CRANBROOK SCHOOL

**RESPONSE TO
SUBMISSIONS**

PREPARED FOR CRANBROOK SCHOOL

Figure 1 - Location of Bicycle Parking

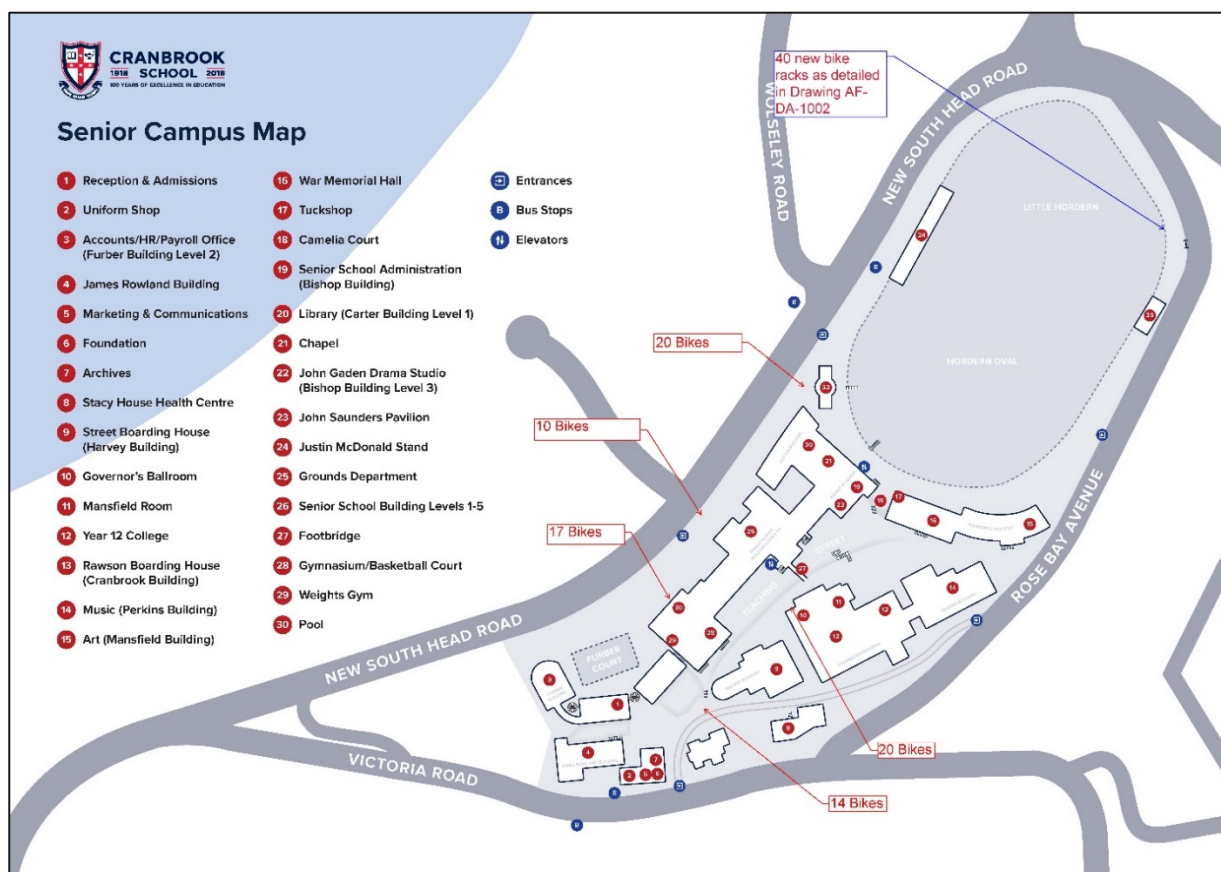
It was also sought that an assessment be provided of the proposed bicycle parking against the Woollahra Development Control Plan (DCP) 2015. Under Clause 11 of *State Environmental Planning Policy (State and Regional Development) 2011*, the application of Development Control Plans is excluded when assessing SSD projects. Notwithstanding this, the proposed bicycle parking has been assessed below:

As part of the School redevelopment, 40 additional bicycle parks are proposed on campus to supplement the existing 81 bicycle parks. Drawing AF-DA-1002 of the Architectural Drawing set at **Appendix A** details the location of the proposed additional 40 bicycle parks and **Figure 1** details the remaining existing 81 bicycle parks. The remaining bicycle facilities are located in the following locations:

Control	Proposal
<p>F2.6 – Traffic, parking and access</p> <p><i>C9 Bicycle parking is provided.</i></p>	<p>The proposed development includes bicycle storage facilities for 121 bikes. Change facilities are provided at level B2 as detailed in Drawing AF-DA-1003.</p>
<p><i>C10 For secondary and tertiary establishments—dedicated secure bicycle parking is provided at the following rates:</i></p> <p>a) 5% of staff numbers</p> <p>b) 10% of full time student numbers;</p> <p><i>At a central location and with associated change rooms and showers.</i></p>	<p>In addition to the 81 existing bike spaces provided on campus, the total bike parking provision on site of 120 spaces exceeds the 118 spaces as required by the DCP.</p>

Figure 3 – Site Plan

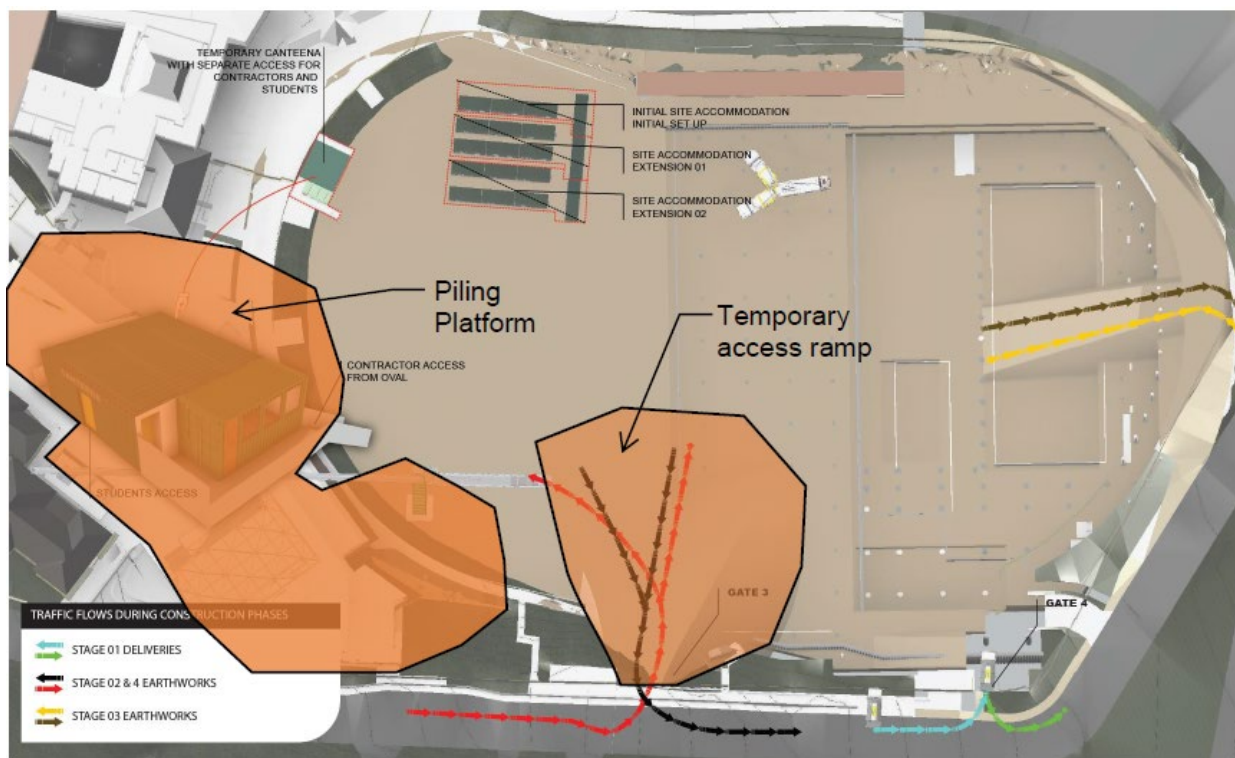
How much of the excavated material is to be retained on-site for reuse and where it is proposed to be stockpiled during construction?

Based on Buildcorp's calculations, approximately 86,000m³ of material is expected to be excavated from the site. Of this volume, approximately 15,000m³ will be retained as a piling platform (**Figure 2**) for approximately 10-months, and approximately 8,000m³ will be retained as a temporary access ramp to/from Rose Bay Avenue (Figure 2) for approximately 18-months. Ultimately, we expect the full volume of excavated material (86,000m³) to be exported from the site.
